Tennessee Valley Authority, 1101 Market Street, Chattanooga, TN 37402

CNL-16-170

Clinch River Nuclear Site  
NRC Project No. 785

Subject: Submittal of Supplemental Information Related to Vibratory Ground Motion in Support of Early Site Permit Application for Clinch River Nuclear Site

**Figure 2.5.2-56. Shear Modulus Reduction and Damping Curves for Firm Rock**

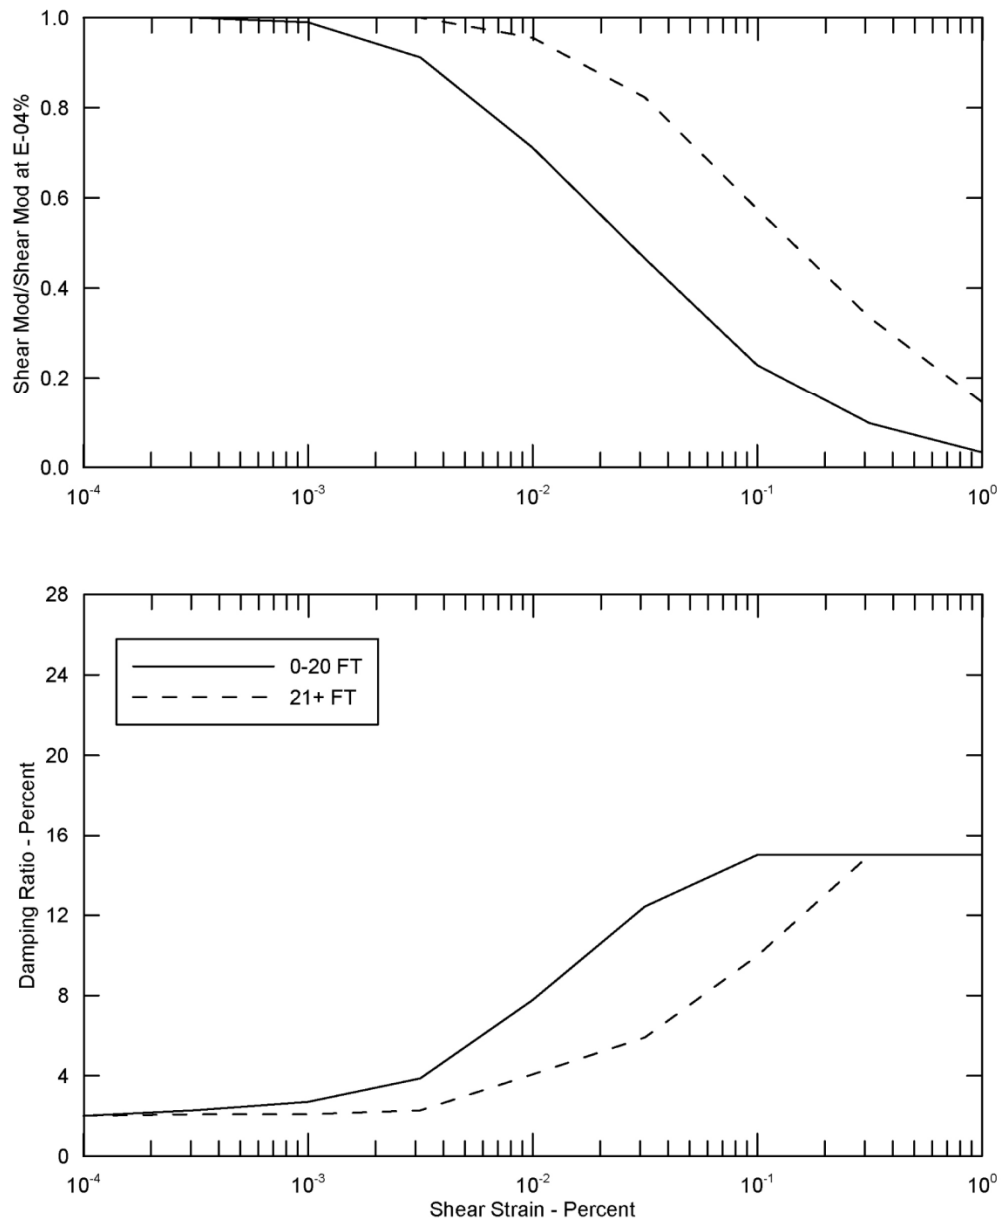
To accommodate potential loading level dependencies on shear-wave velocities and hysteretic damping within the shallow sedimentary rock column at the CRN Site, a modified subset of the EPRI rock modulus reduction and hysteretic damping curves (Reference 2.5.2-142) was used (Figure 2.5.2-56) along with equivalent-linear site response analyses. The curves were

Figure 2.5.2-96. Clinch River and TVA Damsite  $V_s$  Profile Sigmas

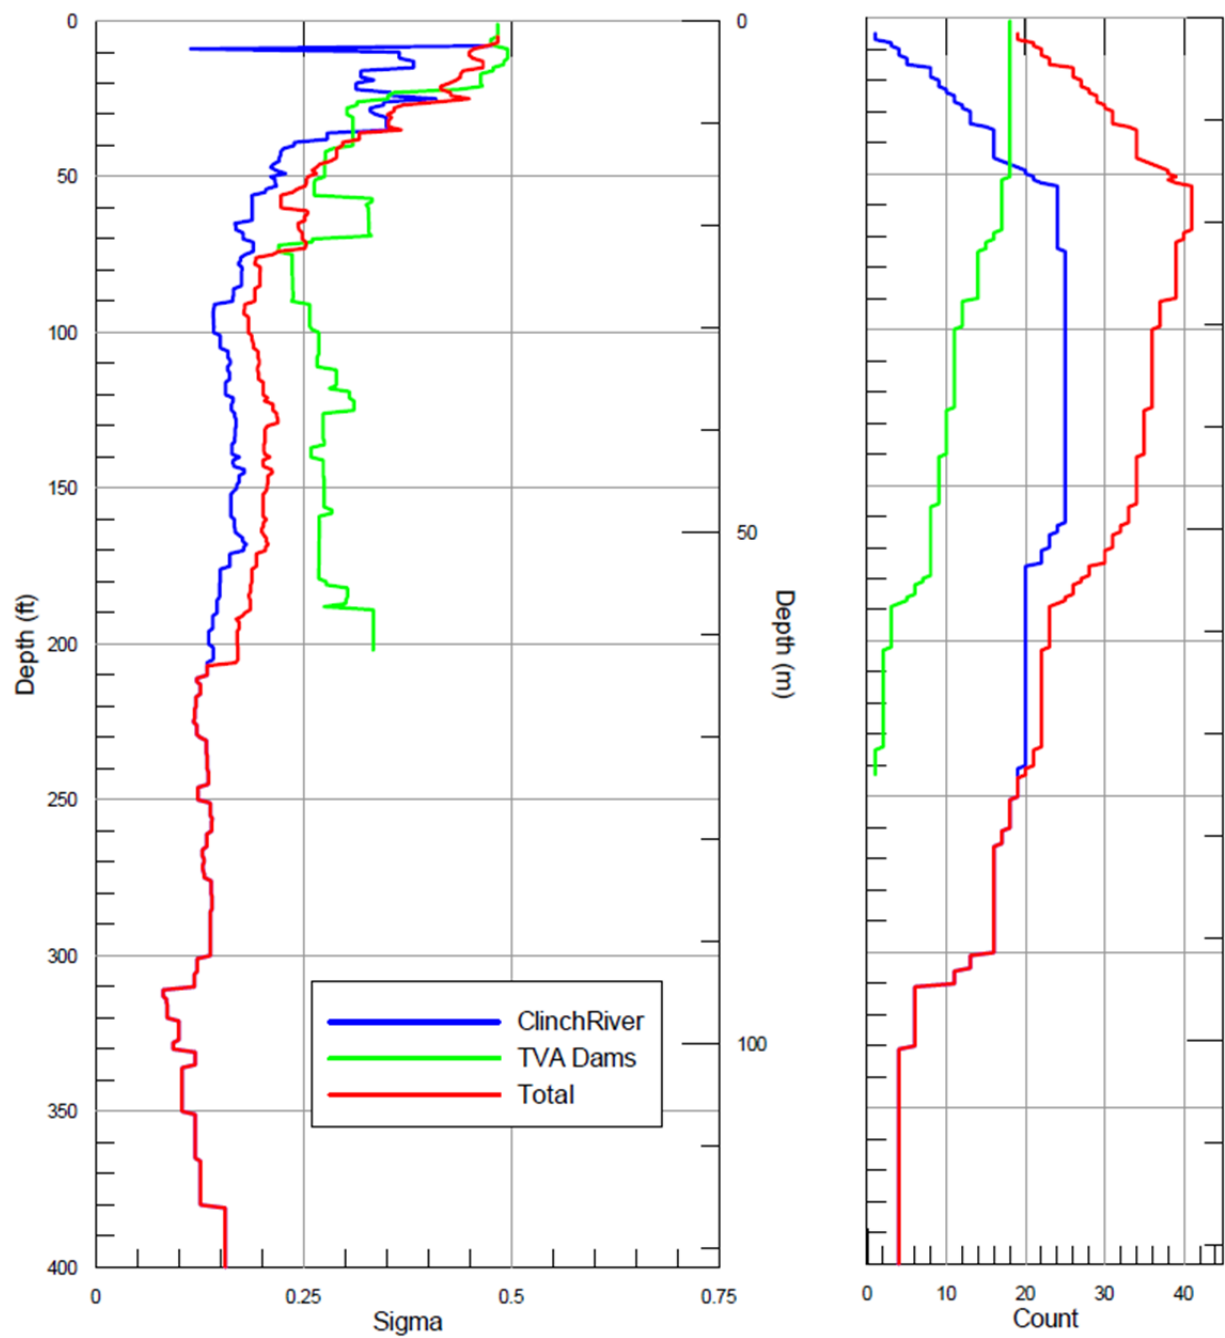
Using these results as well as the sigma across units at the CRN Site in Figure 2.5.2-96 to inform judgment in developing depth-independent epistemic uncertainty, a standard deviation of 0.15 was selected to accommodate potential 2D effects in the top 300 ft where 2D effects may be expected to be the strongest in the shallow strata but still minor, as well as lack of site-specific measurements below a depth of about 300 ft. Considering a three-point approximation to the distribution weights of 0.2, 0.6, and 0.2 for lower (P2)-, middle (P1)-, and upper (P3)-range estimates results in a velocity scale factor of approximately 1.25, a  $\pm 25\%$  variation about the mean (best estimate) basecase. The resulting base-case (P1) as well as lower-range (P2) and upper-range (P3) basecases are illustrated in Figure 2.5.4-20 and 2.5.4-21 for Locations A and B, respectively. The resulting range in  $V_s$  from the lower- to upper- base-cases is about 1.6 and well within the range for such materials (Reference 2.5.2-208), acknowledging a portion of the range was taken to accommodate the dipping structure.

**Figure 2.5.2-101. Interpreted shear-wave velocity at Tellico Dam. Velocity from suspension log in Boring TLH-4**

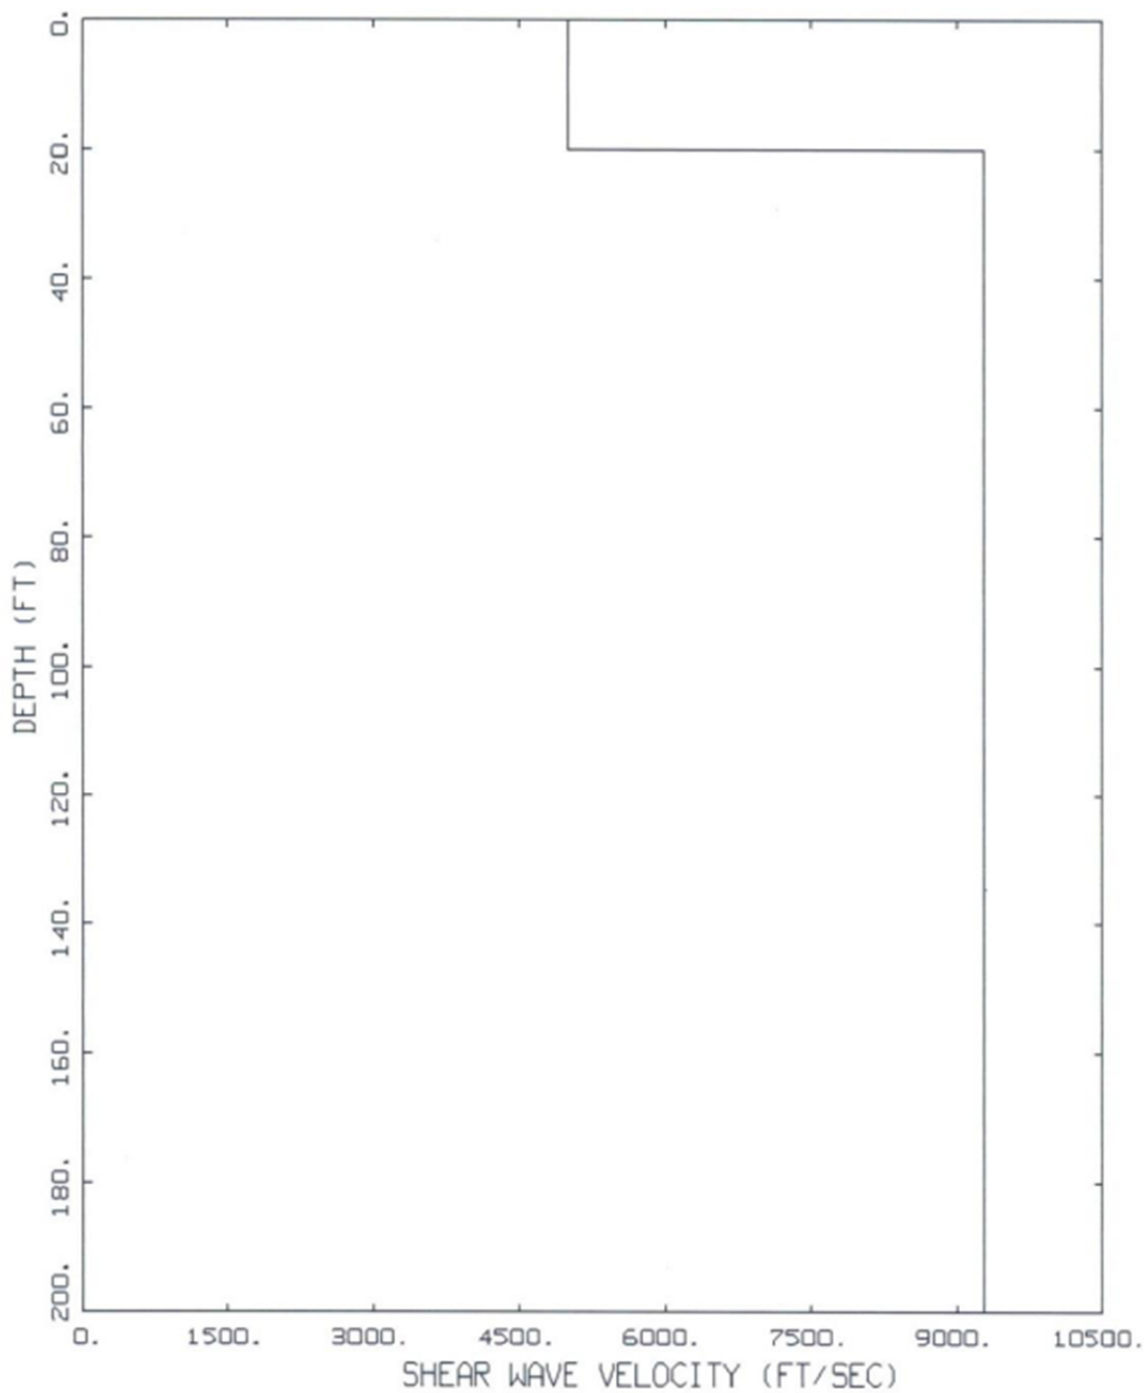
Figure 2.5.2-101 shows the smoothed and interpreted  $V_s$  at the site based on the OYO suspension logging. The top 6.1 m (20 ft) of soil and weathered rock is represented as a single layer with a  $V_s$  of 1,524 m/s (5,000 fps) overlying hard rock with a  $V_s$  of 2,830 m/s (9,285 fps).

**Figure 2.5.2-102. Smoothed Tellico Dam crustal transfer functions for local crustal model with a surface shear-wave velocity of 1,524m/s in the top 6.1m (20 ft) over hard rock (2,830m/s)**

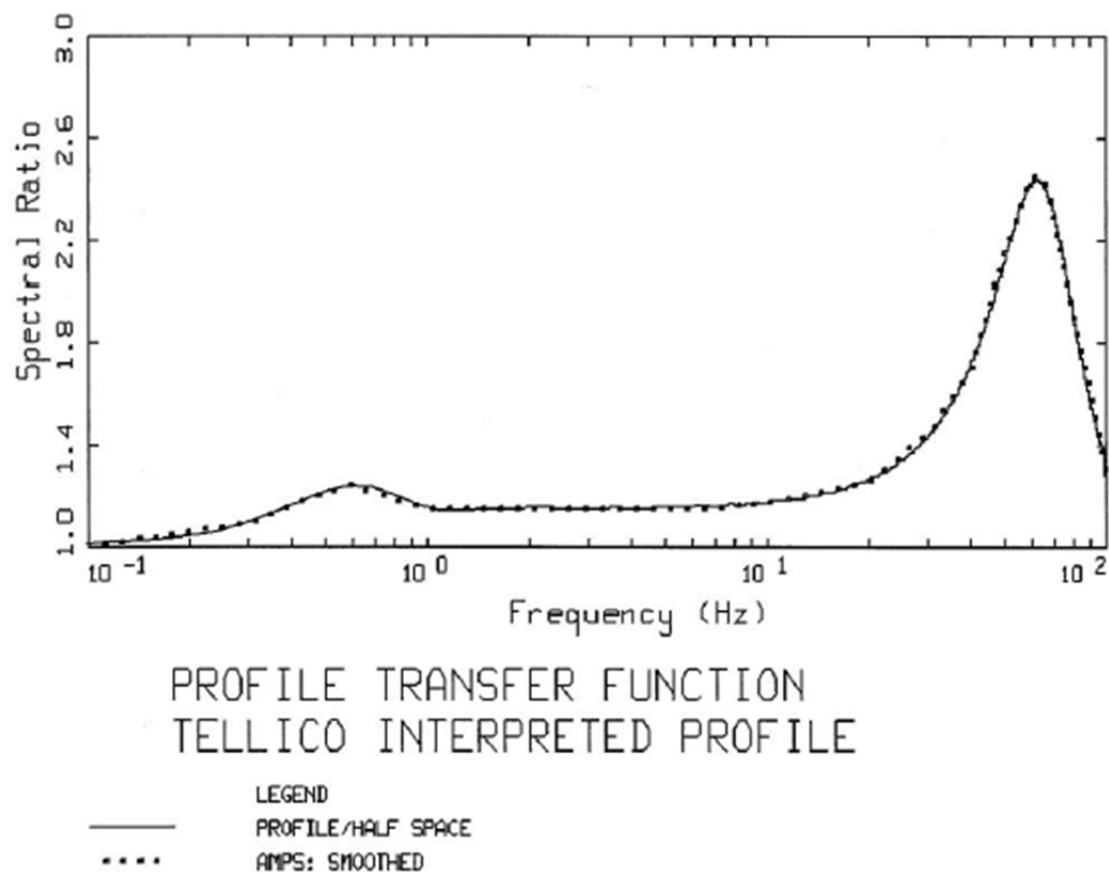
Using the base case Q(f) correction,  $630 f^{0.5}$  (Reference 2.5.2-186) and the shallow amplification factors (Figure 2.5.2-102) the best estimate of kappa was a median 0.0098s with an aleatory variability of  $\sigma_{ln} = 0.8$  over the 12 earthquakes listed in Table 2.5.4-32. For comparison, including the five earthquakes with limited bandwidth (but excluding the two earthquakes with negative kappa estimates) increases the estimate slightly to 0.011s,  $\sigma_{ln} = 0.5$ .

Figure 2.5.1-30. Geologic Cross-Section K-K' of the Clinch River Nuclear Site

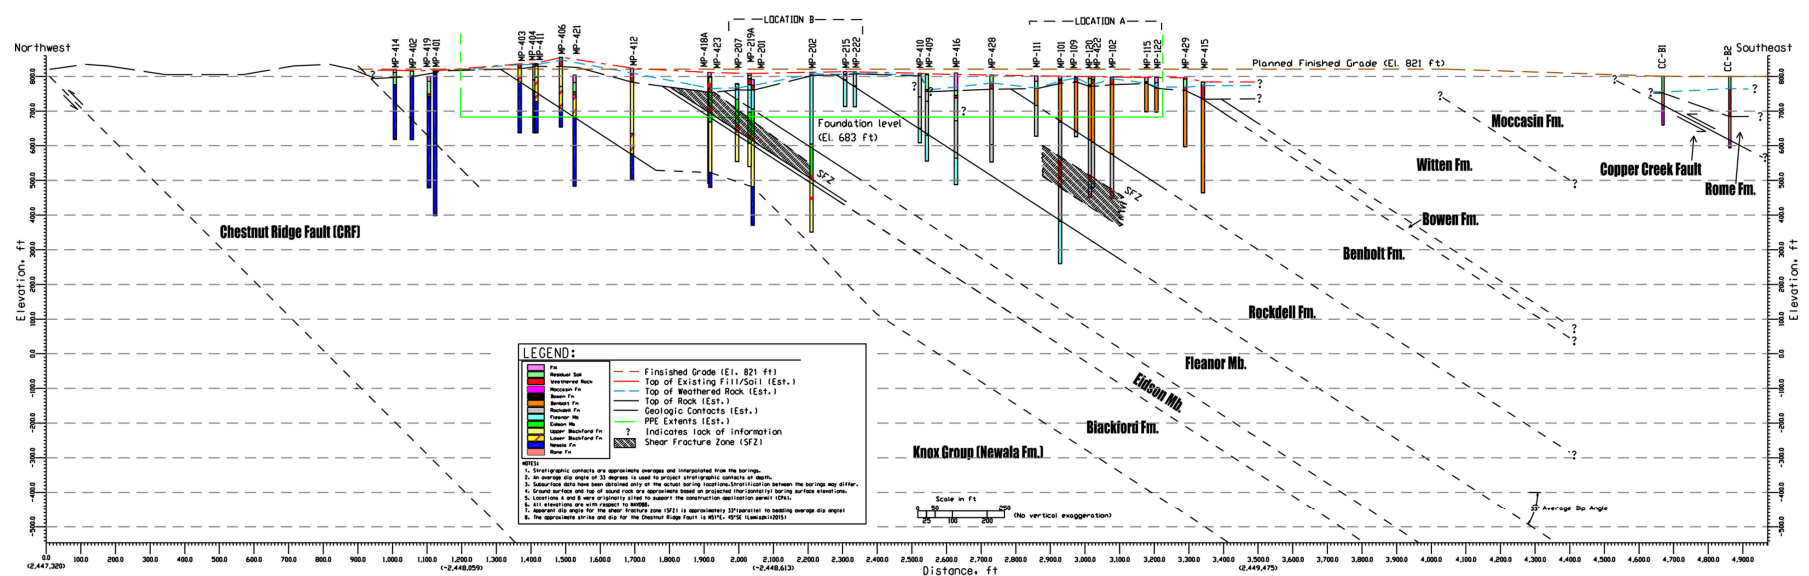
2. SSAR Figure 2.5.1-30

A copy of the revised Figure 2.5.1-30 is included in this enclosure.
